Planning Commission Staff Report

Subject: Rezoning Vote Report

Petition: P.Z. 38-2007 Edison Crossing (162 Long Road)

EDISON CROSSING
PRELIMINARY PLAN

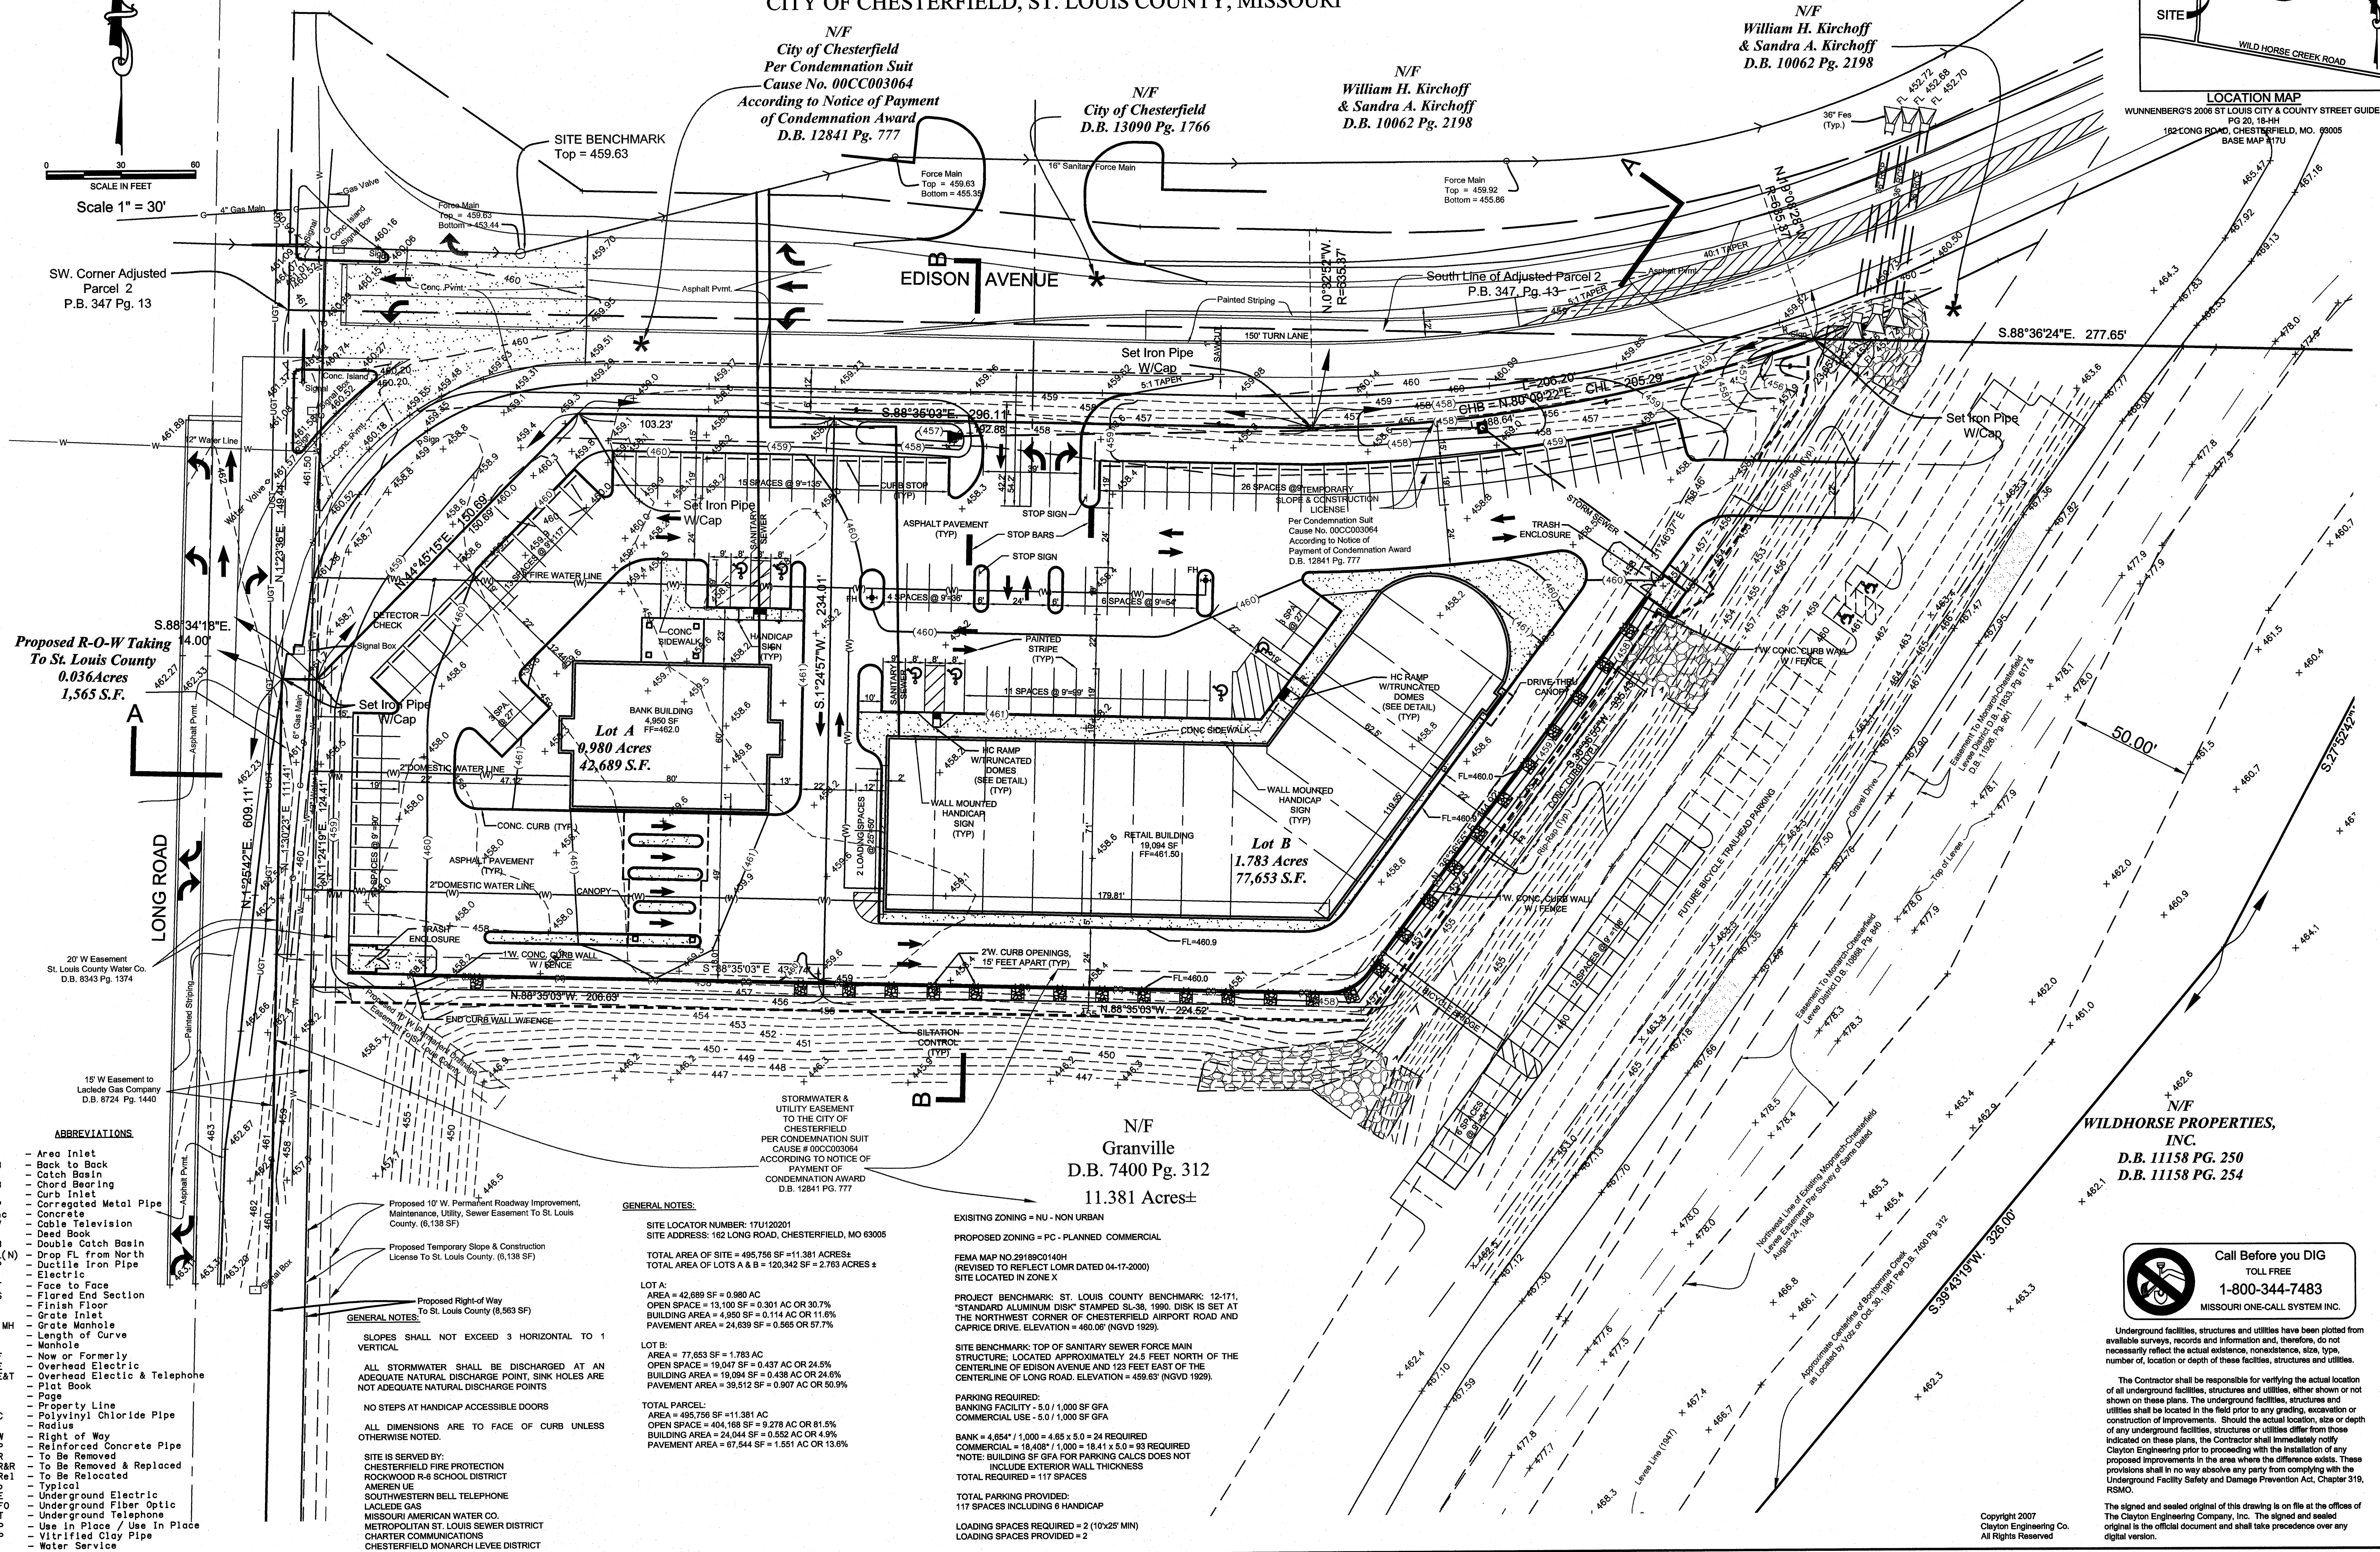
3. Please clarify the rectangular area behind the retail building toward the eastern end of the building.

4. The City of Chesterfield Tree Manual requires a thirty (30) foot buffer along collector and arterial roadways. This buffer cannot be within the parking areas as currently shown on the plan.

5. Please provide the open space calculation for the section of the parcel to be developed.

6. The parking calculations are not consistent with the building square footage shown on the plan. Please revise.

8. Please provide the building footprint calculation based on the development area of the parcel.

10. The current plan does not provide adequate driveway throat length for the entrance on Edison Avenue. The City's access management principals, found in Chapter 26 article III of the City Code, require a minimum of 60 feet from the edge of the pavement on Edison Avenue to the first point of conflict within the site. The distance as measured on the plan is 47 feet.

Petitioner's Response: This has been clarified on the revised Preliminary Plan.

Petitioner's Response: A separate request for reduction of this buffer will be submitted.

Petitioner's Response: This information has been provided on the revised Preliminary Plan.

Petitioner's Response: This has been corrected on the revised Preliminary Plan.

Petitioner's Response: This has been provided on the revised Preliminary Plan.

Petitioner's Response: A separate request for a variance of this requirement has been submitted.
